**VHF radiotelephone equipment for general communications  
and associated equipment for Class "D"  
Digital Selective Calling (DSC);  
Harmonised Standard ~~covering the essential requirements for~~  
access to radio spectrum and  
~~of articles 3.2 and for features for emergency services~~  
3.3(g) of Directive 2014/53/EU**

REN/ERM-TG26-517TGMAR-608

**Figure 1: Frequency deviation**

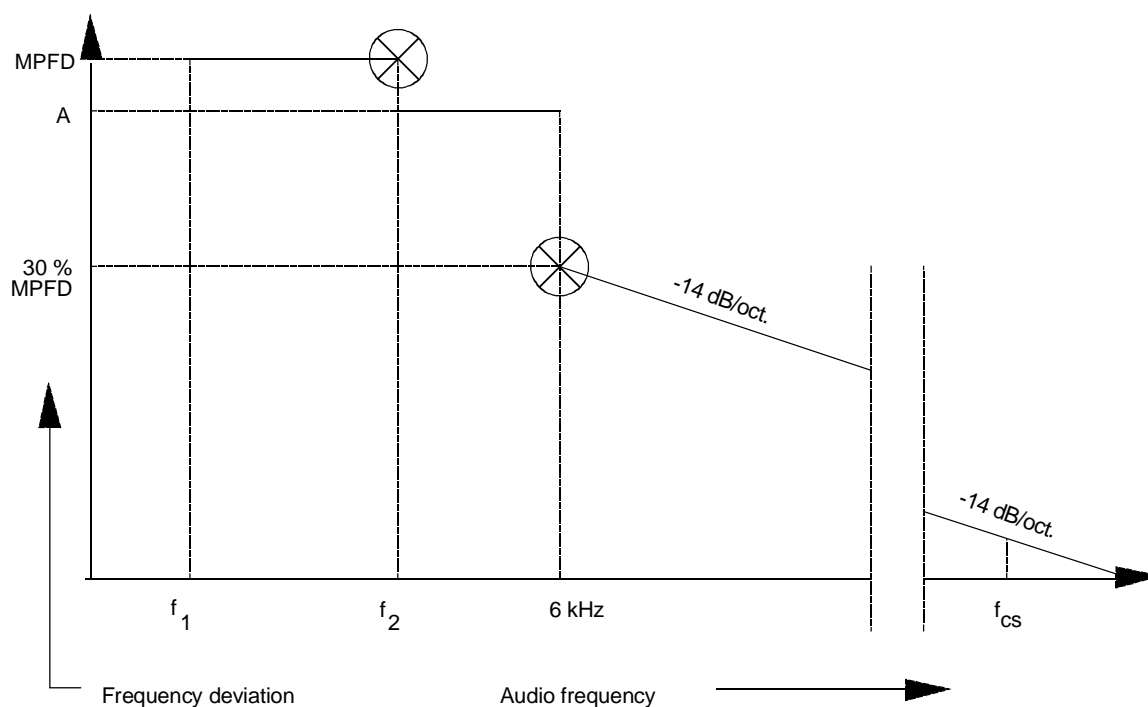
## 8.3.3 Reduction of frequency deviation at modulation frequencies above 32,55 kHz

~~NOTE: — 2,55 kHz for transmitters intended for 12,5 kHz channel separation.~~

The frequency deviation at modulation frequencies between 6,0 kHz and a frequency equal to the channel separation for which the equipment is intended shall not exceed that given by a linear representation of the frequency deviation (dB) relative to the modulation frequency, starting at the 6,0 kHz limit and having a slope of -14,0 dB per octave. These limits are illustrated in figure 1.
